U.S. Department  
Of Transportation  
**Federal Highway  
Administration**

Refer to: HNG-14/SS-34

Geometric and Roadside Design Acceptance Letter Number SS-34

Figure 1. Multi-directional slip base, single steel sign support installation.

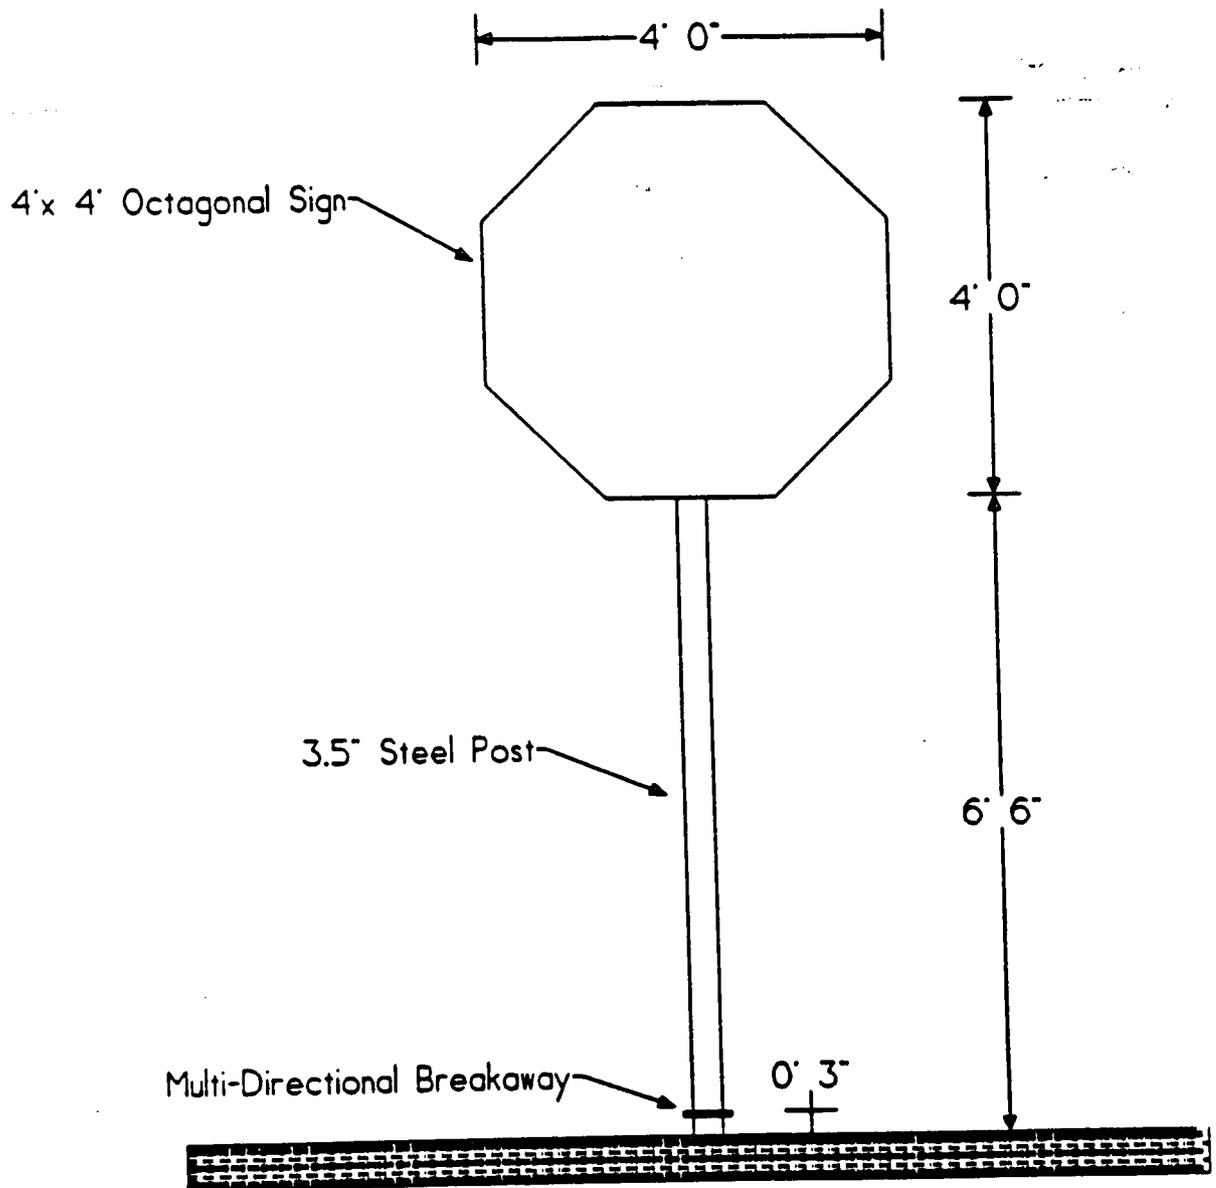
The Louisiana breakaway base is a horizontal, triangular slip base design. It was tested with an 89-mm (3 1/2-in) diameter, schedule 40 steel pipe sign post. The three 16-mm (5/8-in) high strength (A325) bolts were torqued to 25.5 N-m (226 in-lb). Three washers were used with each bolt, one each under the head and the nut of the bolt and one between the slip plates. The base post was mounted in a 450-mm (1-foot, 6-inch) diameter concrete foundation. An illustration of the test article and a detailed drawing of the omni-directional slip base are enclosed.

The results of these tests meet the change in velocity and stub height requirements adopted by AASHTO and the FHWA.

Therefore, the tested omni-directional steel slip base described above is acceptable for use on Federal-aid highway projects, within the range of conditions tested, if proposed by Louisiana or any other State. We would caution users of this slip base that both the bevel on the inside diameter of the upper slip plate and the washers separating the slip plates are critical to proper breakaway performance. If either feature is missing the upper slip plate may hit the risers on the lower plate before the bolts have been knocked out of their slots. This would case the base to “lock up” and stop the vehicle.

Our acceptance is limited to the breakaway characteristics of the system and does not cover its structural features. Presumably, your plans and specifications will provide sufficient information on structural design and installation requirements to ensure proper performance.
